SUBDIVISION REVIEW SHEET**CASE NO.:** C8J-2021-0206.0A**COMMISSION DATE:** November 1, 2022**SUBDIVISION NAME:** Srivathanakul Subdivision**ADDRESS:** 101 Lago Verde Drive**APPLICANT:** Sunti and Janice Chen Srivathanakul**AGENT:** KTCivil Solutions (Jonathan Fleming, P.E.)**ZONING:** LA (single family residence) / E.T.J.**NEIGHBORHOOD PLAN:** n/a / E.T.J.**AREA:** 1.408 acres (61,332.48 sf)**LOTS:** 1**COUNTY:** Travis**DISTRICT:** 10**WATERSHED:** Lake Austin**JURISDICTION:** Limited Purpose / 2-Mile E.T.J.**VARIANCE:**

**CITY OF AUSTIN – TRAVIS COUNTY – SINGLE SUBDIVISION OFFICE
SUBDIVISION APPLICATION – MASTER COMMENT REPORT**

CASE NUMBER: C8J-2021-0206.0A
 REVISION #: 00 UPDATE: U0
 CASE MANAGER: Cesar Zavala PHONE #: 512-974-3404

PROJECT NAME: Srivathanakul Subdivision, Lot 1 Block A
 LOCATION: 101 Lago Verde Dr.

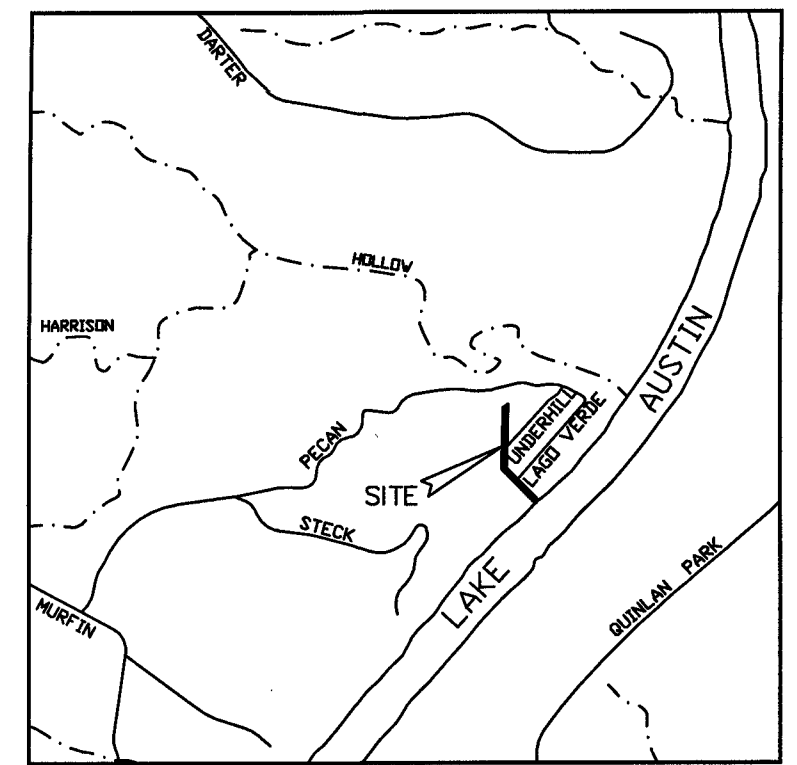
AD2: In the vicinity map please remove the label for STECK, it is not a dedicated named road.

AD3: In the vicinity map please update the label for DARTER and replace it with KOLLMEYER DR as it reads here.

SHEET 2 OF 4

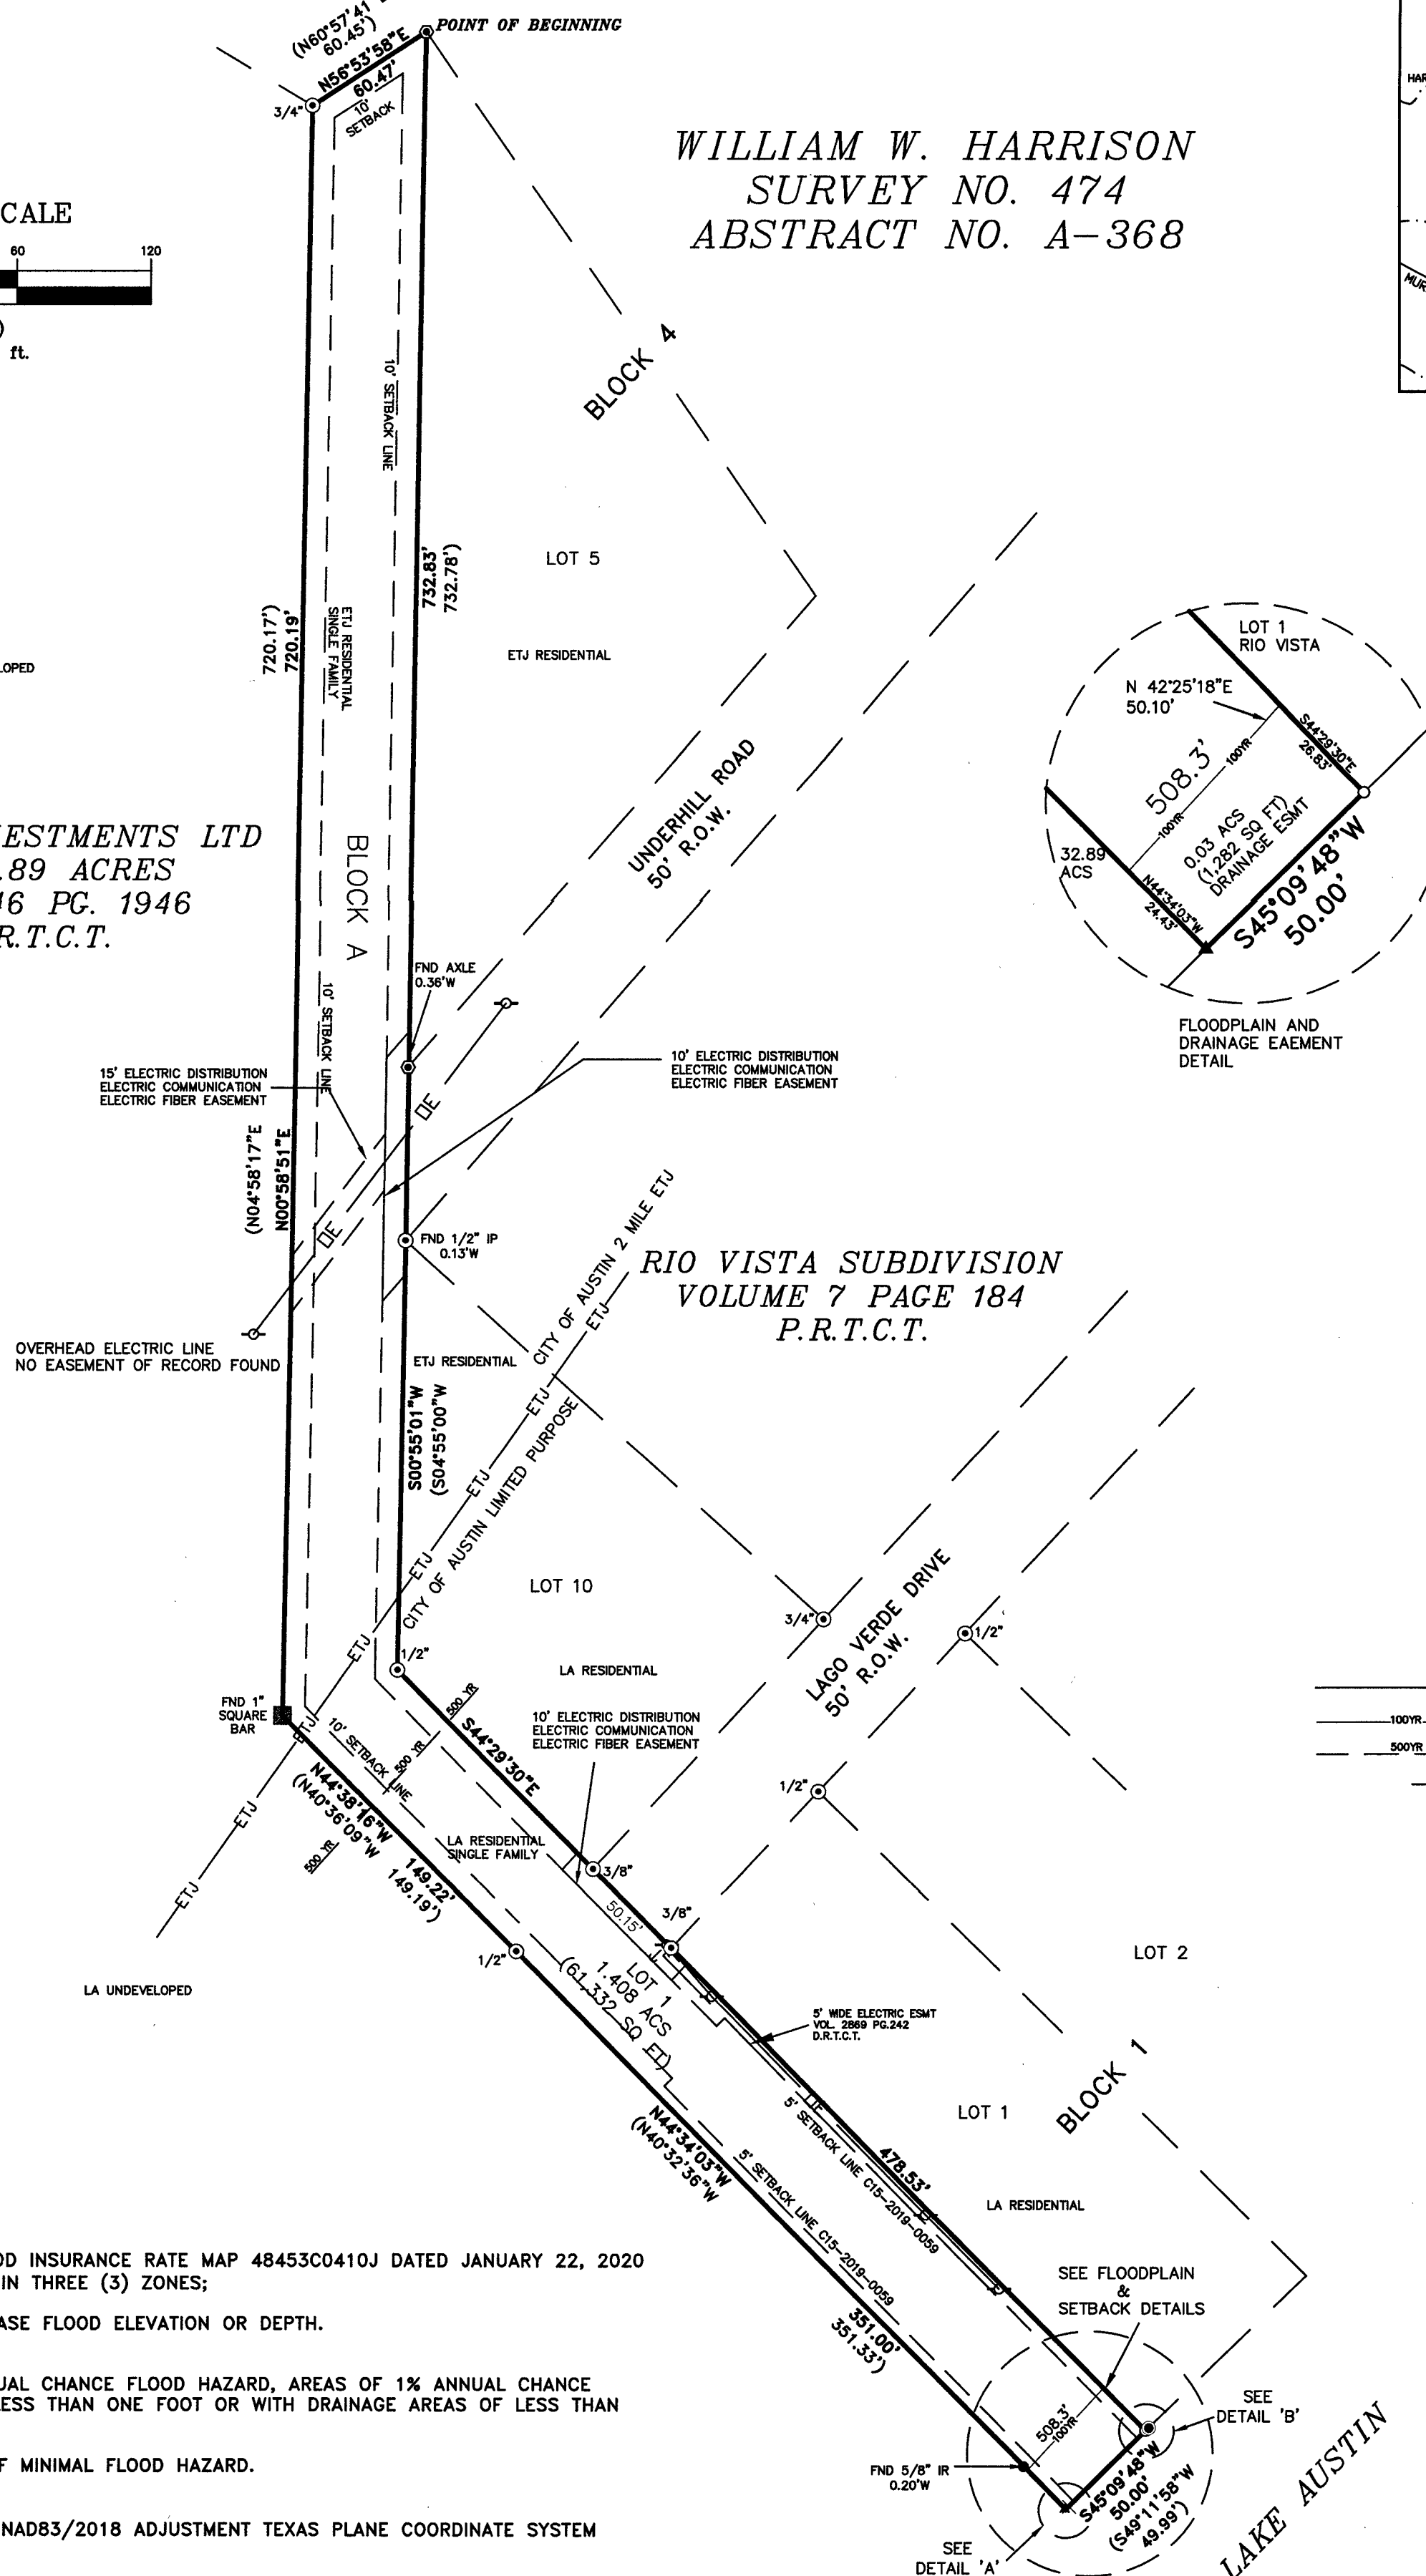
Ten (10') electric distribution, electric telecommunications, and electric fiber easement is required to cover existing single phase OH line. Show the easement on the face of the plat.

EV 01 Add the following to plat note number 31-d: "Any additions to the existing house will be located to the northwest of the existing house to minimize disturbance to the Critical Water Quality Zone."

- Fiscal due (if needed): April 2, 2023
 - Recording due: April 26, 2023
- SR 2. Remove the building setbacks from inside the lots, unless a reviewer requested that the building setback be shown on the plat.
The Travis County group may have requested that certain setback be placed related to flood plain, contact the Travis County Engineer to verify which setbacks should be shown on the plat.

- SR 3. In the owner's preamble on the plat correct the last name for Janice Che Srivathanakul.
- SR 4. Verify the application fees, this case is a final plat with variances, commission approval, and notice of the public hearing. Contact the Intake Department to verify the application fees.
